Rate of Change of Frequency (ROCOF)

Review of TSO and Generator Submissions

Final Report

**Submitted to: Commission for Energy
Regulation**

Source: Eirgrid/SONI report: “ROCOF Modification Proposal – TSOs’ Recommendations”

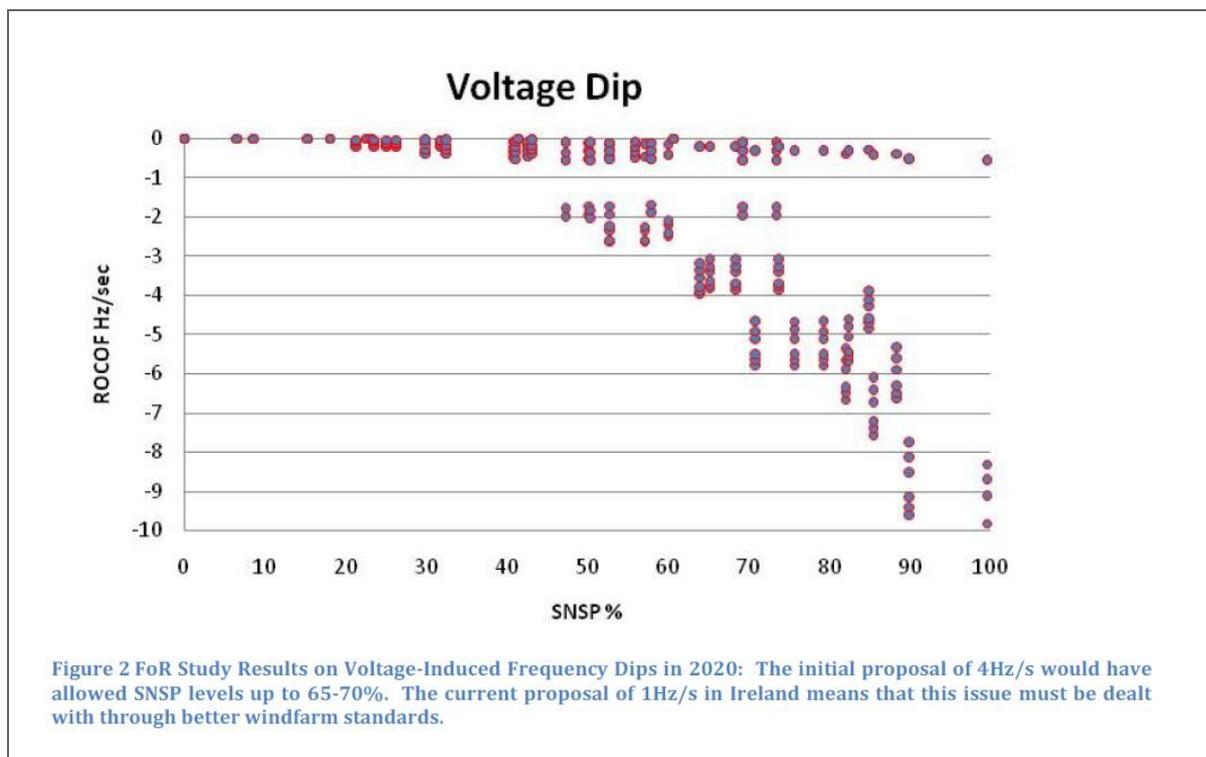
This diagram shows the very rapid increase in the level of (negative) ROCOF that occurs following voltage dips as SNSP increases above 40%.

It is clear therefore that at levels approaching 75% of SNSP, levels of ROCOF of up to 6 Hz/s will become more frequent occurrences on the network. Further analysis would be required to investigate the relative numbers of fault events on the system that would lead to the higher levels of ROCOF.
